ALLUVIAL FAN STABILITY ASSESSMENT (FDC 93-53)

Task 4 of Contract FCD 93-53

**Compare and differentiate between Figure 5 in WRI 91-4171 and
Figure A5-1 in 1985 FEMA Guidelines.**

Hjalmar W. Hjalmarson, P.E.

Figure 1.--Profiles for Las Vegas Wash Tributaries
(From DMA report)

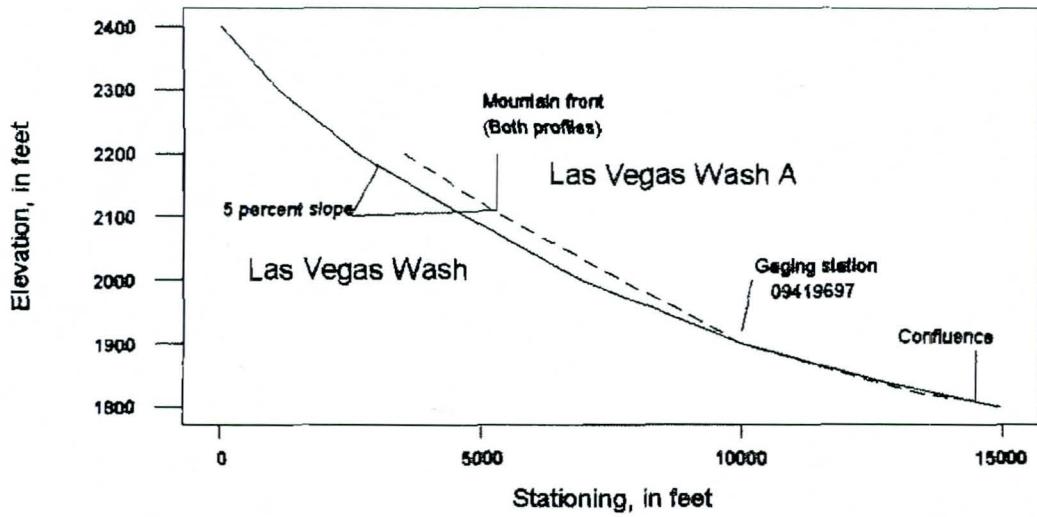
For Las Vegas Wash Tributary, the dividing point between the drainage basin and the fan could not be clearly identified because the "fan slope extends into the canyon upstream of the mountain front" (DMA, 1985, p. 23) apparently upstream of the gaging station. In order to determine the drainage area and peak discharge (DMA, 1985, p. 58), the point on the stream channel separating the drainage basin and the fan is the gaging station but to determine the factors used to develop the graph in figure A5-1 (see Exhibit A), a second point on the stream channel upstream of the gaging station and above the mountain front is used. This second point appears to be located where the profile slope is about 0.050 (DMA, 1985, p.23) almost 5,000 ft. upstream of the gaging station (figure 1). There is no

clear indication in the DMA report that the apex of the "fan" and the location of the gaging are at different locations but the listing of data in tables 2 and 3 (Exhibits C and D of this report) indicates the apex and gage are at the same location.

The profile slope for Las Vegas Wash Tributary does not equal 0.050 until well within the canyon upstream of the confluence with a large tributary. There is little valley fill at this location and floodwater appears to be confined to a single channel for at least 1,000 ft. downstream where the channel slope is less than 0.050. In fact, an active alluvial fan upstream of the gaging station is not apparent on the aerial photograph and topographic map in the DMA report.

It is writer's opinion there are data errors for Las Vegas Wash Tributary in the DMA report that cannot be easily resolved.

The canyon mouth or point of separation of the canyon and the fan appears to closely coincide with the mountain front for Las Vegas Wash A. The slope of the stream profile is the reported fan slope of 0.056 (DMA, 1985, p. 24) a short distance above the mountain front (figure 1). About 3,400 ft. below the "canyon mouth" the channel is bounded on the right by a levee (DMA, 1985, figure 5). This point closely corresponds to the location where the channel reportedly splits and changes into braided sheet flow. The presence of levee, whose remnants reportedly are depicted on the four sets of photographs (DMA, 1985, p. 24), at the time of the floods is unknown to this writer. It would appear the levee could have a significant effect on factors such as the length of the channel and the fan radius (see Exhibit 2).

How and where the canyon mouth is located is unclear based on the confusing differences between the two sites. The use of factors determined at different locations along Las Vegas Wash Tributary (See table 3, DMA, 1985) is equally confusing. It would be difficult to select the canyon mouths of other sites based on information presented for these two sites. Perhaps this is the source of the confusion exhibited by consultants working with distributary-flow areas in Arizona a few years ago.

Figure 2.—Profile for Lytle Creek near Fontana, CA
(From DMA report)

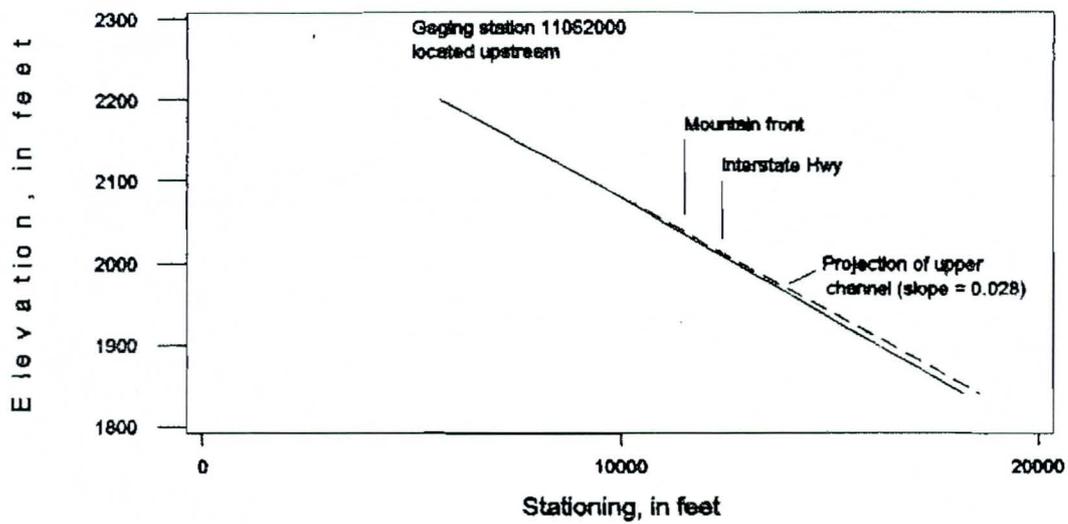
The network of channels below the gaging station on Lytle Wash near Fontana, California appears to be part of a braided channel and not an alluvial fan. The braided channel may be of the Holocene Epoch while the fan may be much older. The channel of Lytle Creek shown on the topographic map is slightly above the land to the right at the interstate highway about 1 mile below the gaging station. This evidence, as depicted on the topographic map, that the channel may be actively aggrading is limited to this location. There appears to be some channel incision along much of the braided channel. Based on the absence of relief transverse to the flow and the large concavity of the contours, the area within the expansion angle of 95 degrees may be part of an active alluvial fan. Information potentially gleaned from soils maps and a field inspection are needed to identify the system.

The location selected for the canyon mouth by DMA(1985, p.32) is unclear and the canyon and channel slopes of 0.031 and 0.026, respectively, are confusing. Using the topographic map in the DMA report with a contour interval of only 40 ft., the profile of the canyon and fan along the centerline of the braided channel indicates a the "fan" becomes steeper rather than flatter downslope (figure 2). A rather constant slope of 0.028 is indicated for the canyon and near the mountain front above the interstate highway the slope changes to a rather uniform 0.029. The slope of 0.026 reported by DMA(1985, p. 32) appears to be for a short reach of fan because it cannot be obtained from the topographic map for any significant distance along the present flow system.

Figure 3.—Profile for Day Creek nead Etiwanda, CA
(From DMA report)

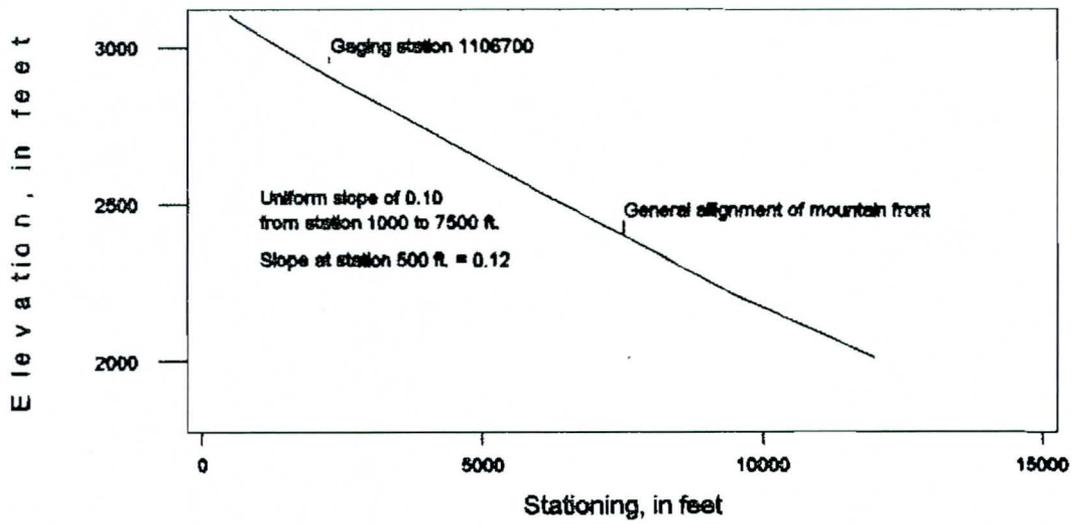
The topographic features for Day Creek (DAM, 1985, figure 10) closely correspond to those in the DMA report (1985, p. 34) except for the slope of the channel above the canyon mouth. The slope of the canyon appears to be less than 0.149 reported by DMA. For example, at 1500 ft. upstream of the gaging station the slope is 0.12 (figure 3). This lesser slope would give a canyon slope-fan slope ratio of about 1.2 which would plot very near the relation in figure A5-1 of the 1985 FEMA Guidelines.

Figure 4.—Profile for Deer Creek nead Etiwanda, CA
(From DMA report)

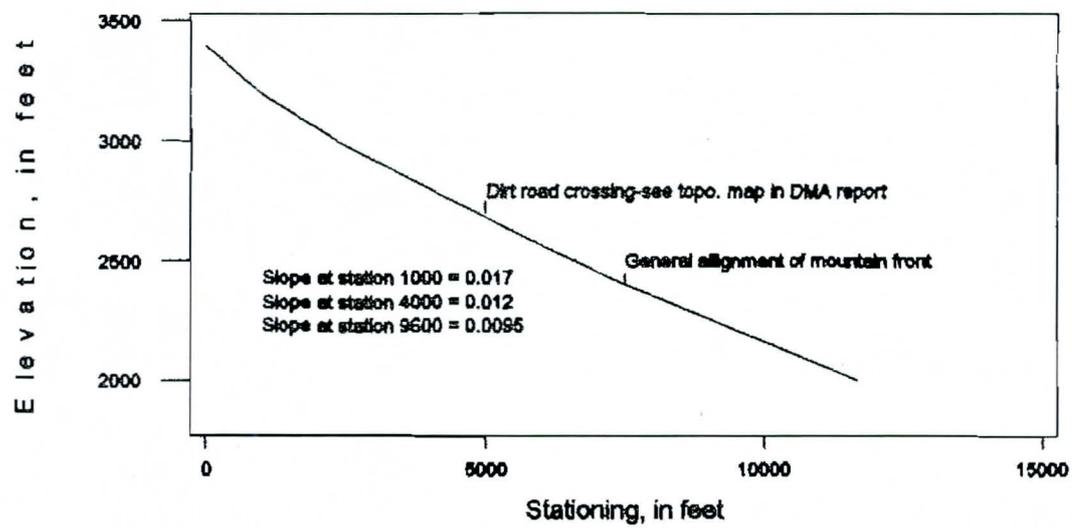
Characteristics of Deer Creek are in agreement with the topography and the slopes are in agreement with the profile for the creek (figure 4). However, because the slope of the creek is gradually decreasing it is difficult to duplicate the slopes published by DMA. The precise location of the canyon mouth as well as the locations of the slope determinations are not defined. Based on the profile (figure 4) the reported fan slope of 0.109 (DMA, 1985, p. 37) appears to be at a location about one mile downstream of the point where the canyon slope was determined. This distance seems to be large for a stream draining only 3.4 mi² but this intuition cannot be checked using the information in the DMA report..

(Figure A5-1 of FEMA, 1985)

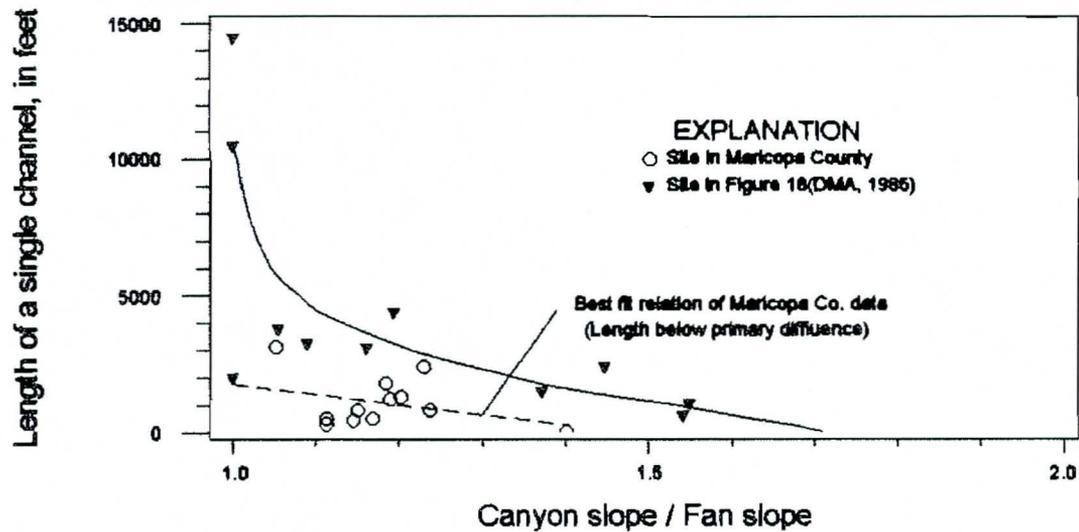
Except for the Northumberland and Plute sites of the DMA study, the data for the 12 Maricopa County sites using the length below the canyon mouth are fairly similar (figure 7). The single channel lengths of the remaining DMA sites are generally larger but there is some overlapping of the plot of data for the two groups. With the inclusion of the Northumberland and Plute sites, however, the data for the Maricopa County sites do not define the relation in Exhibit A. The relation between the length of single channel and the ratio of canyon slope to fan slope defined by DMA (Exhibit A) and shown in figure A5-1

of the 1985 FEMA Guidelines is not confirmed by data collected at 12 sites in Maricopa County. The relation is not supported by DMA using physical processes and thus, there is no way to explain the differences between the Maricopa Co. data and the relation. The relation in figure A5-1 apparently does not apply to sites in Maricopa County.

FIGURE 18
 Relationship Between Observed Length of a Single Channel and the Ratio of Canyon Slope to Fan Slope

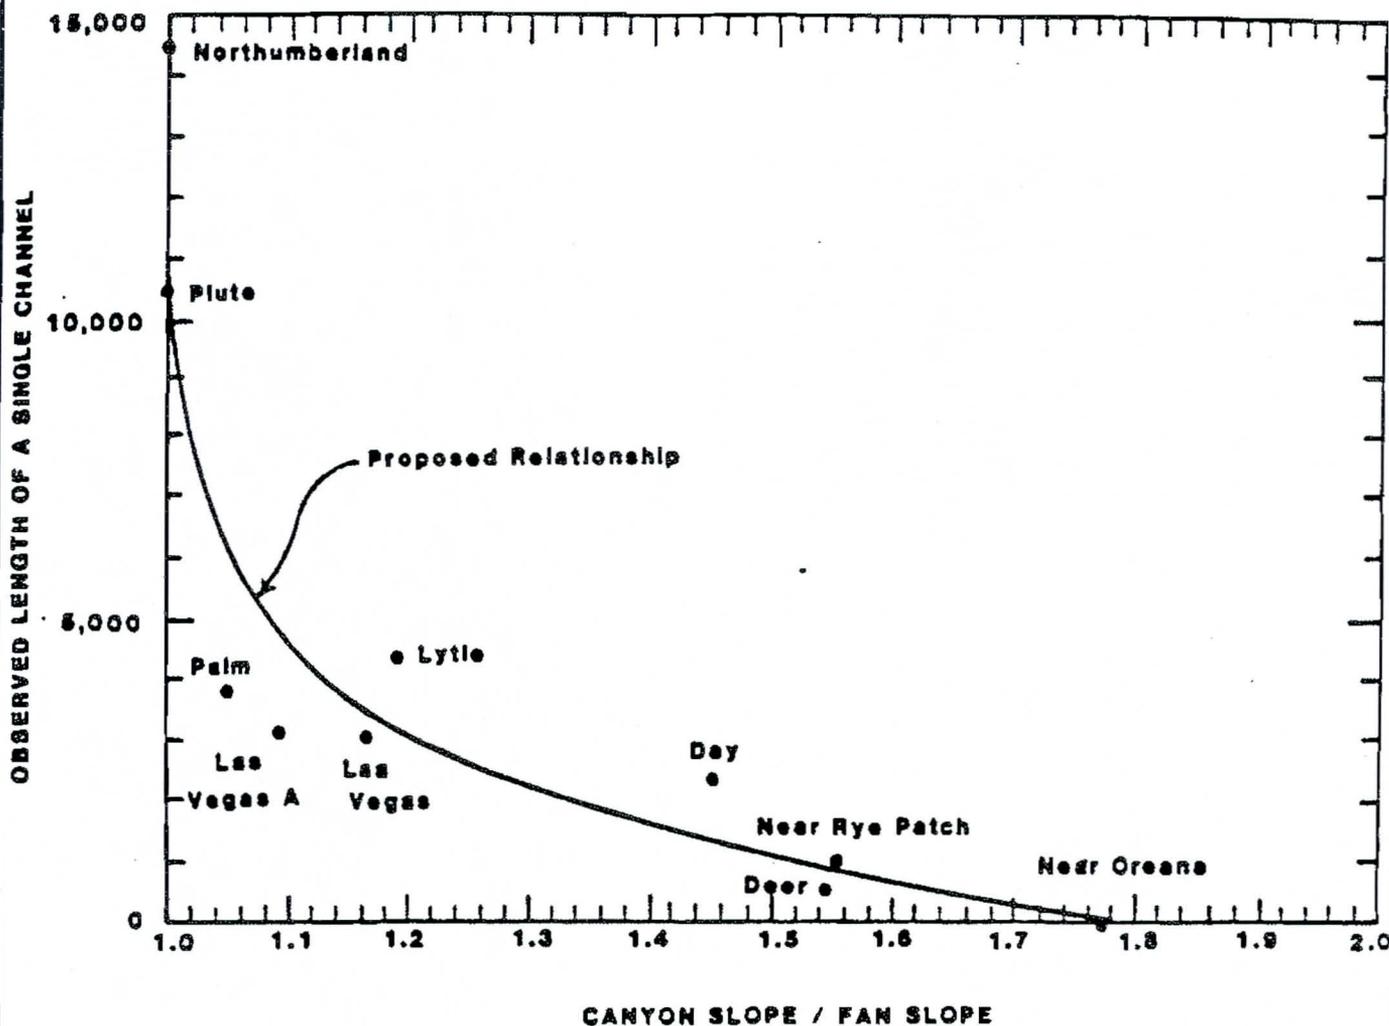
The factors such as canyon slope, fan slope and observed length of the single channel used for the relation in figure 18 (DMA, 1985) cannot be duplicated because specific criteria for the definition of the location of the (1) canyon mouth, (2) determination point for the canyon slope, and (3) determination point for fan slope are missing in the DMA report and in the 1985 FEMA Guidelines. The review of the DMA methods for the above sites indicates inconsistent criteria were used by DMA and that some of the results are in error.

The writer's second concern is the authors' use of the graph developed by DMA ("Alluvial" 1985) or FEMA ("Flood" 1985) because there are errors in the data used by DMA. There are several certain and probable data errors in the DMA report. The writer suggests the graph developed by DMA is incorrect for the following reasons:
